The Barn Hotel, West End Road, Ruislip

LPA REFERENCE 7969/APP/2023/1473 & 7969/APP/2023/1833

**RESPONSE TO LB HILLINGDON FEEDBACK ON TFL, URBAN DESIGN AND
CONSERVATION, ACCESS, POLICY & PUBLIC OPEN SPACE**

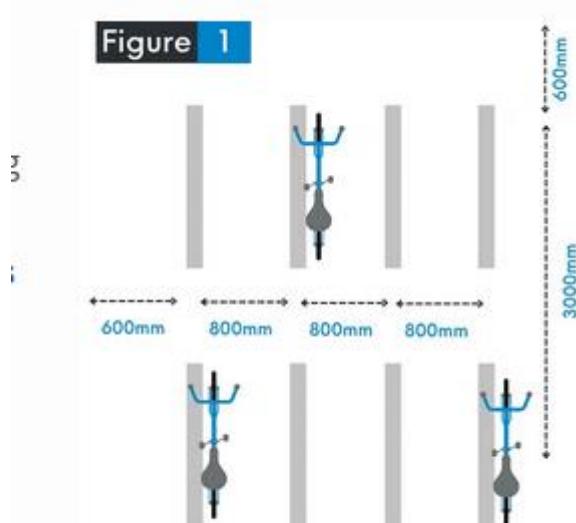
However, the cycle parking is not compliant against the London Cycle Design Standards (LCDS). A minimum spacing between Sheffield stands of 1m should be achieved with a recommended width of 1.2m, currently the plans are suggesting the spacing between stands is 0.4m.

The spacing between stands is 0.8m not 0.4m. This is predicated upon the recommendations by the suppliers, extract from Broxap below. We have not encountered such a response from TfL before on this subject. Other suppliers also recommend 0.8m.

Having installed many hundreds of Sheffield stands on our schemes we have never encountered any issue with the spacing. At this point we consider the plans as drawn to be acceptable, but would be happy to discuss further with the Local Planning Authority if they consider otherwise.
